APPEAL OF RESOLUTION PB-18-23

Marriott Residence Inn

2900 Harbor Bay Parkway

PRESENTATION TO ALAMEDA CITY COUNCIL
FEBRUARY 5, 2019

PROPOSED PROJECT

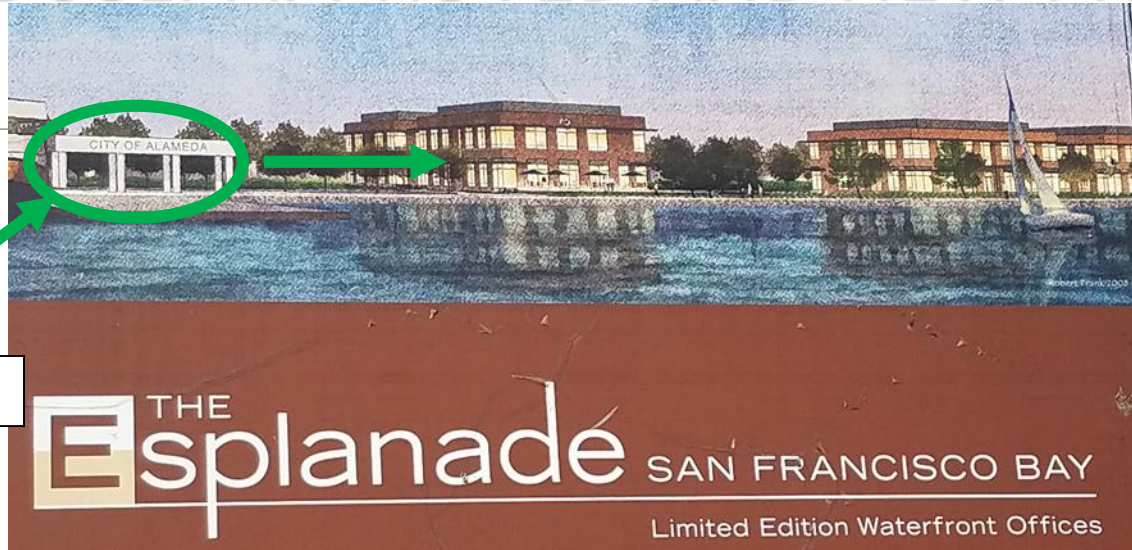
Does this “blend in” to the shoreline?

(NO)

PROJECT Design violates PB Resolution #1203 dated December 1, 1981

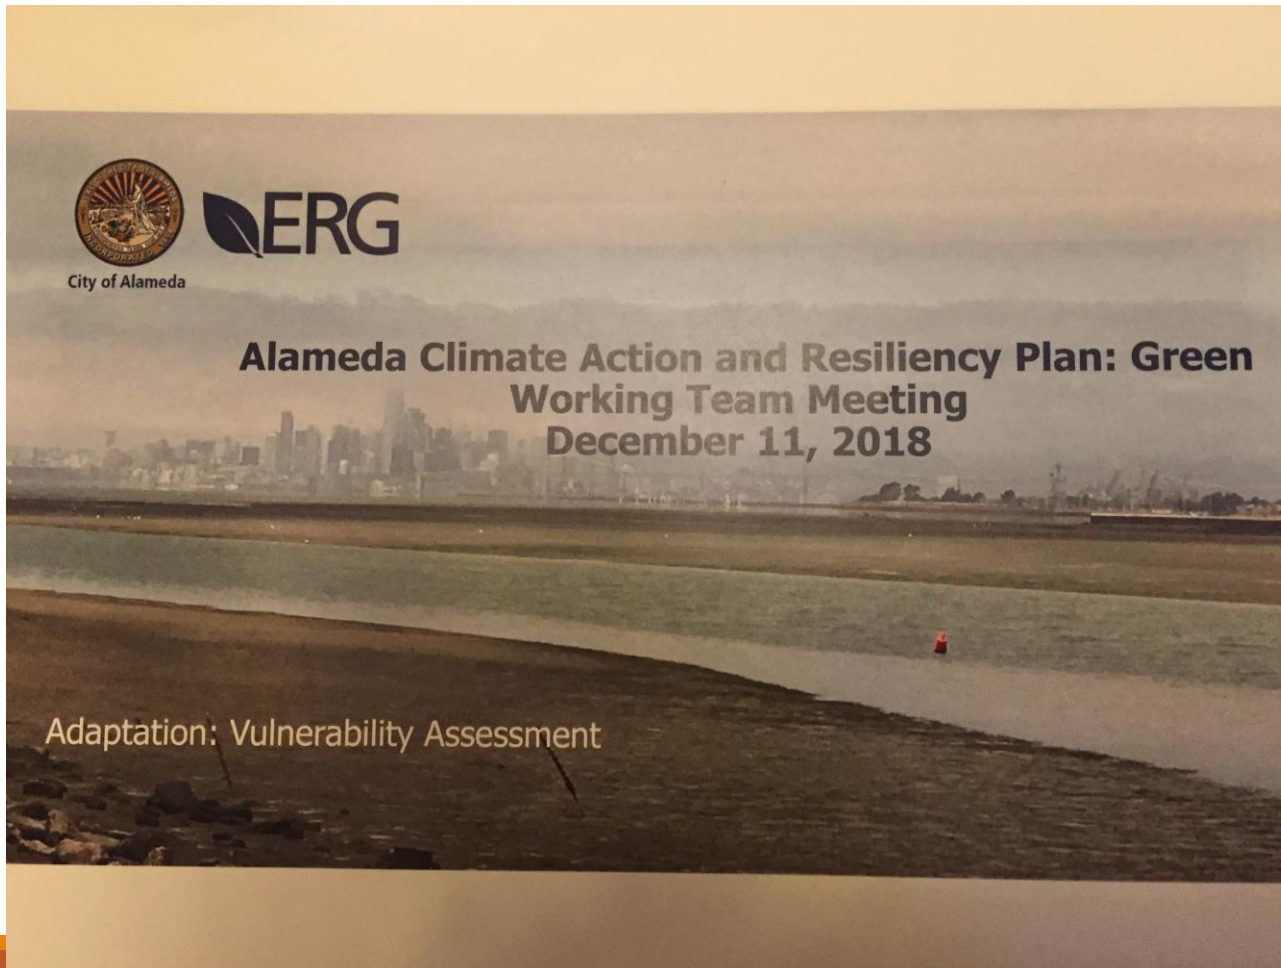
- Under Para. B, Architecture:
 - Prominent buildings should be placed along Harbor Bay Parkway spine - **NO**
 - Protection of the Hills to Bay continuity - **NO**
 - Design attention to minimize or mitigate architectural bulk - **NO**

Proposed development is **entirely out of scale** to the Bay Shoreline, and adjacent residential and commercial development.
